FILE NH000-0056-01(061), Fulton County
SR 400 at CR 145/Northridge Road
P.I. # 751580-

SUBJECT Request for Design Variance – Roundabout Lighting

Subject: **Request for Design Variance**
NH000-0056-01(061), Fulton County
P.I. No. 751580-
SR400/US19 @ CR145/Northridge Road

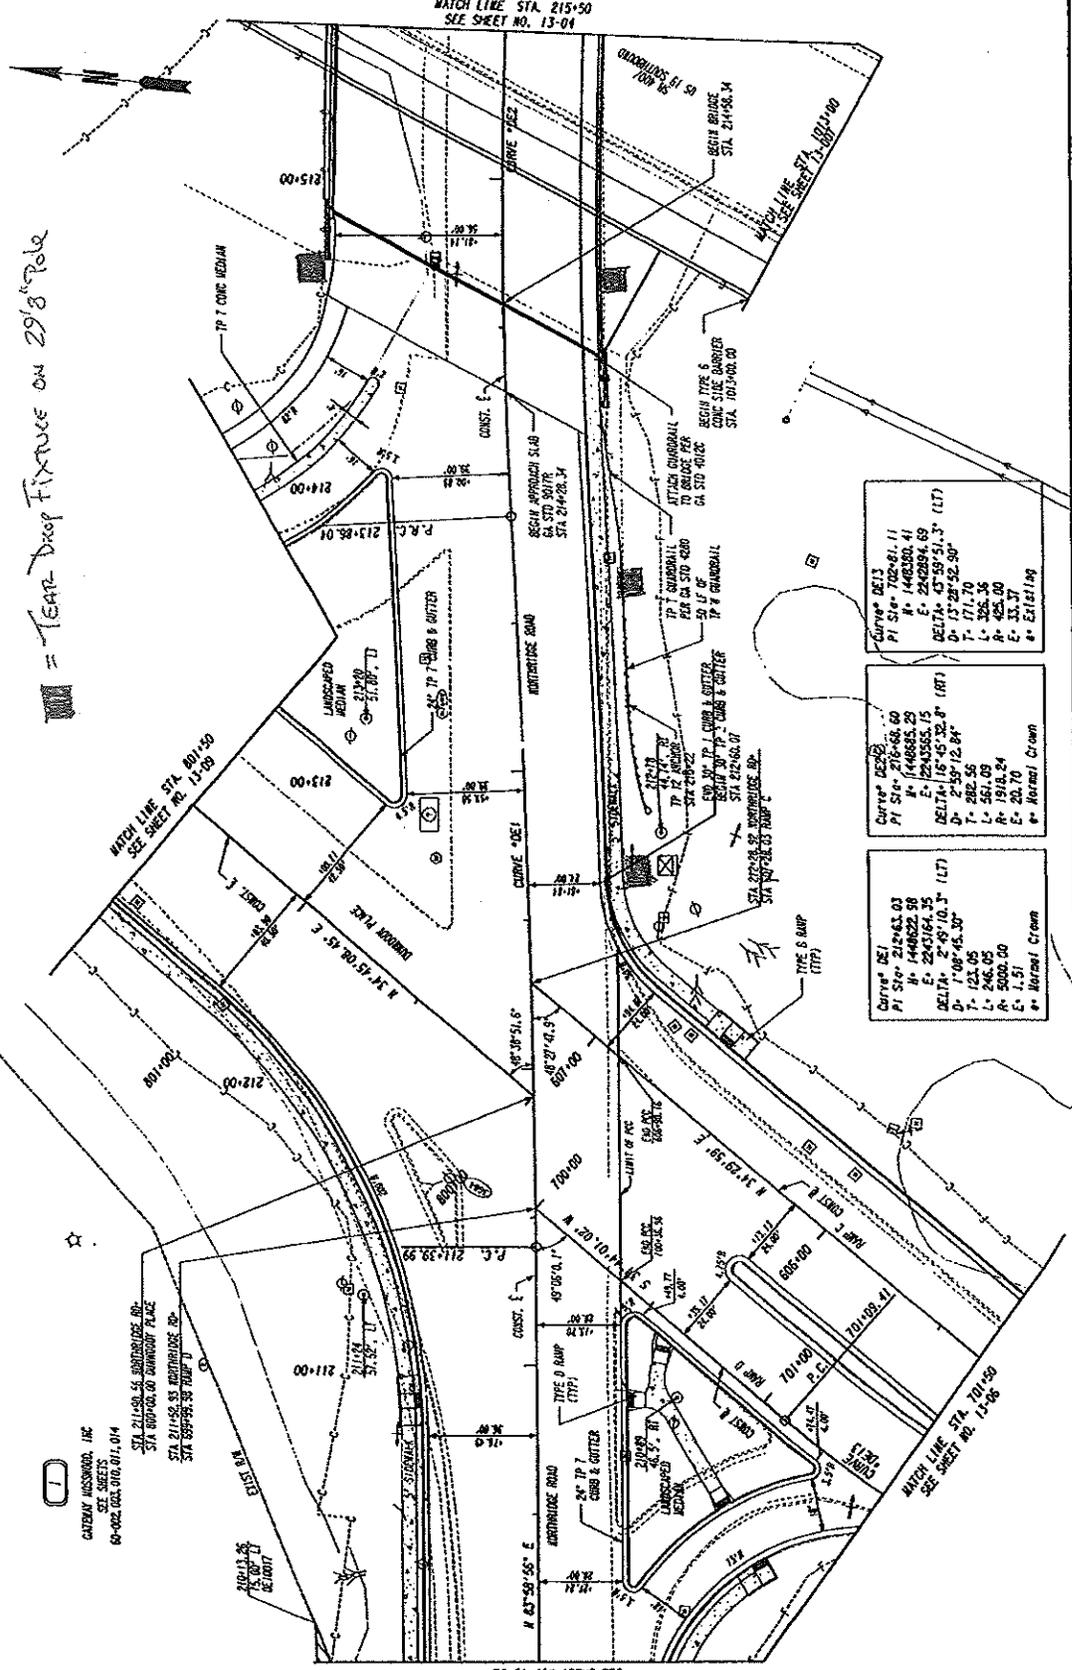
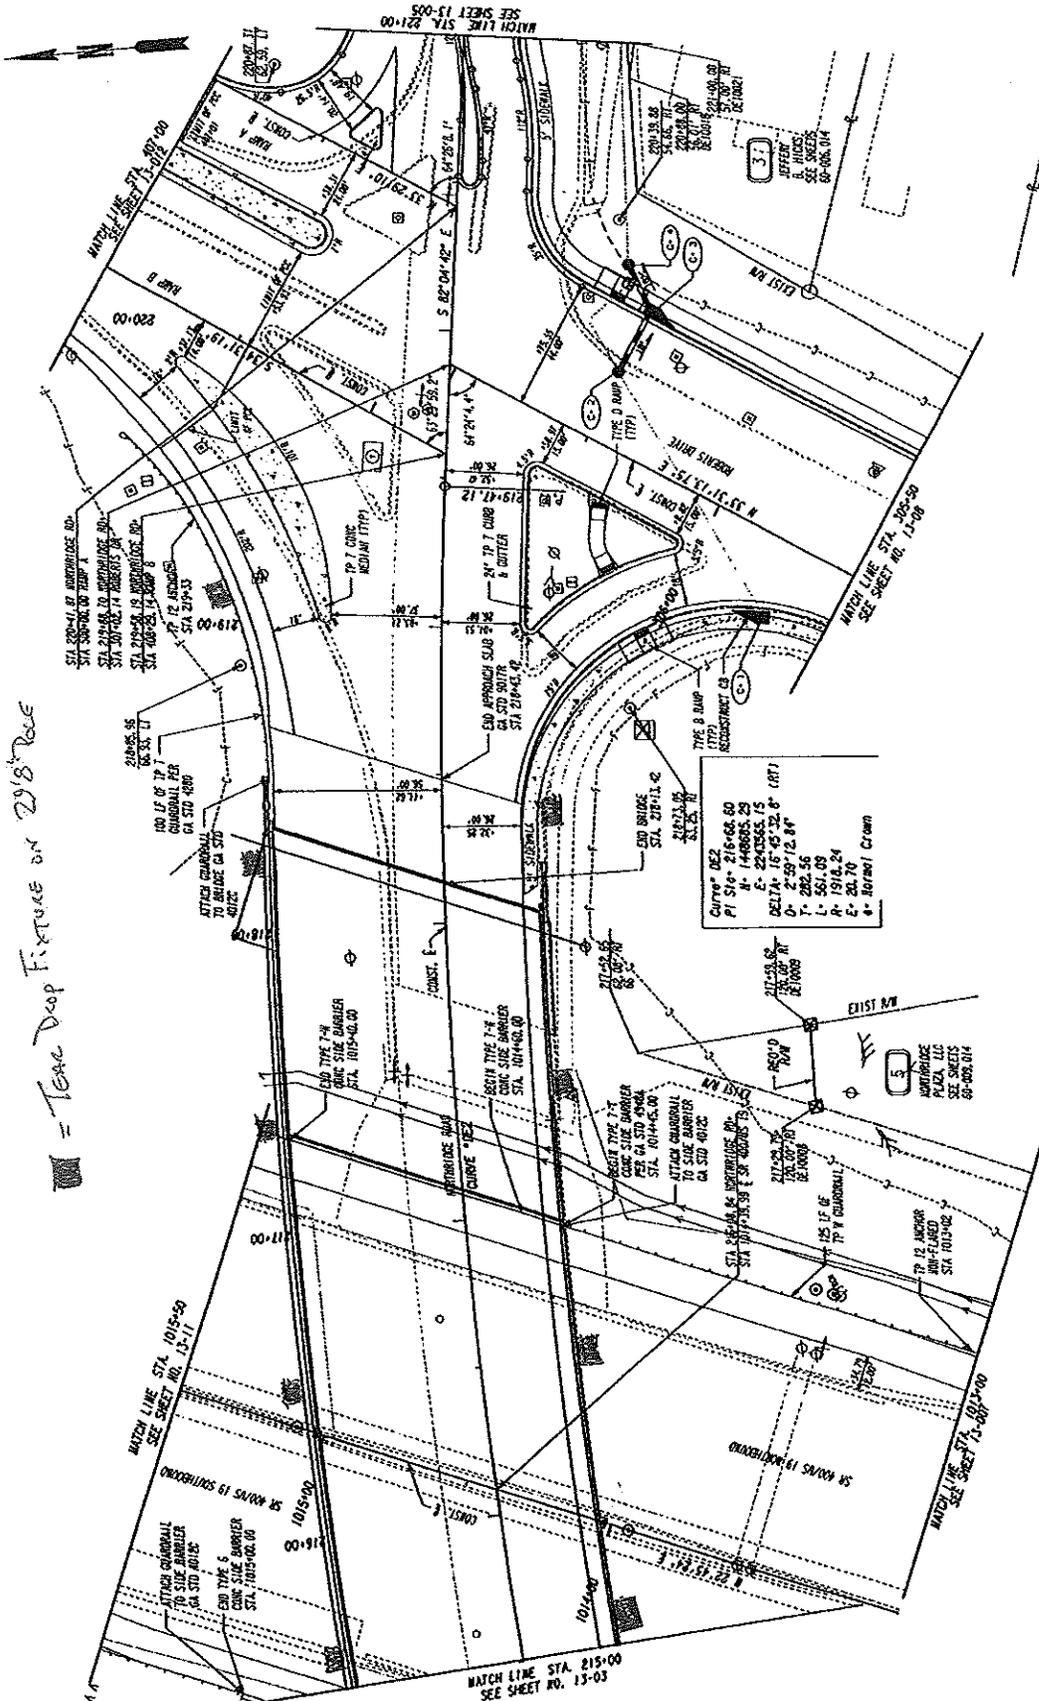
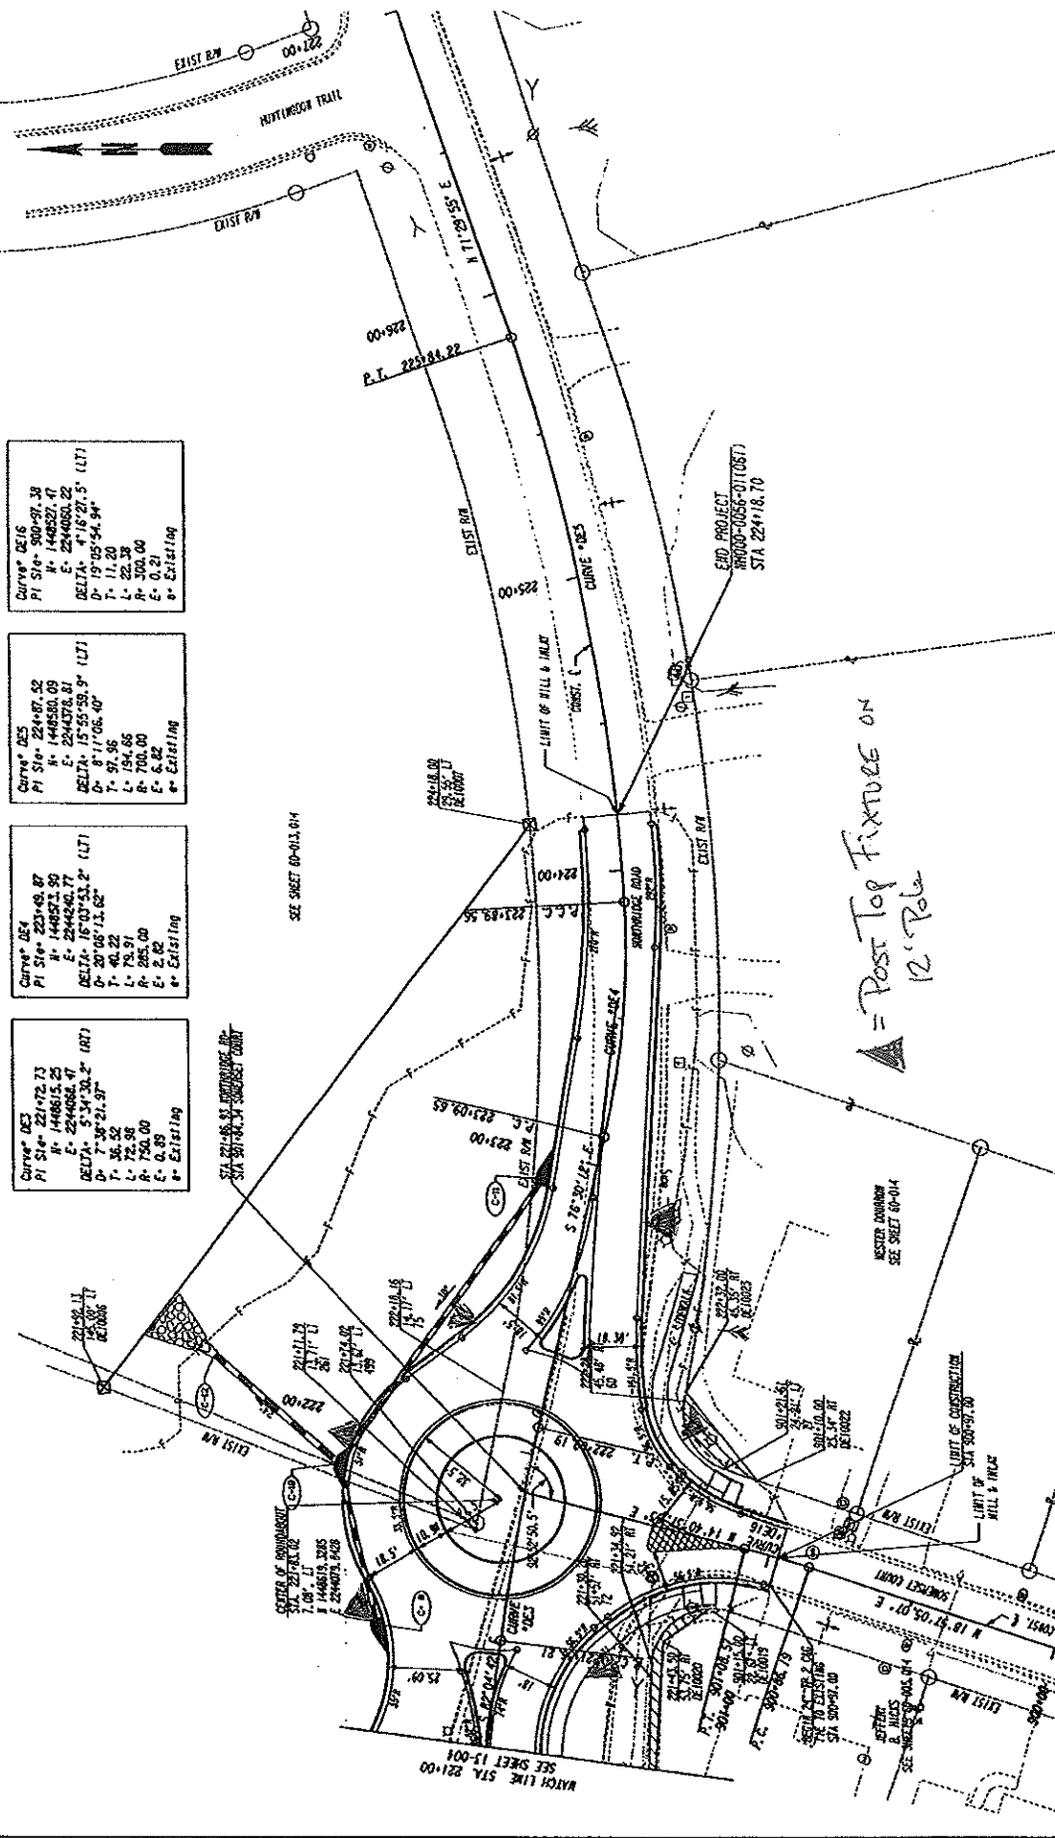
A design variance is requested for roundabout lighting transition requirements of 80 meters (262 feet) beyond the roundabout. The proposed project will have a lighting transition of 66 feet beyond the roundabout's east approach.

Transition lighting of 80 meters (262 feet) for the eastbound approach of the roundabout will not be met due to the coordination with the local neighborhood. Coordination with the neighborhood occurred during Public Information Open Houses and stakeholder meetings which led to the neighborhood's request to not have roadway lighting within the neighborhood beyond the roundabout.

The section of Northridge Road east of the roundabout is a residential street consisting of low volumes (Design Year AADT = 2050) and low speed (25mph). The west side of the roundabout will be included in the roadway lighting across the bridge. The installation of 66 feet of transition lighting will include the illumination of the east bound and Somerset Court splitter islands. The installation of this lighting along with roadside signs and pavement markings will provide mitigation necessary to lessen the impact of not providing 262 feet of transition lighting east of the roundabout.
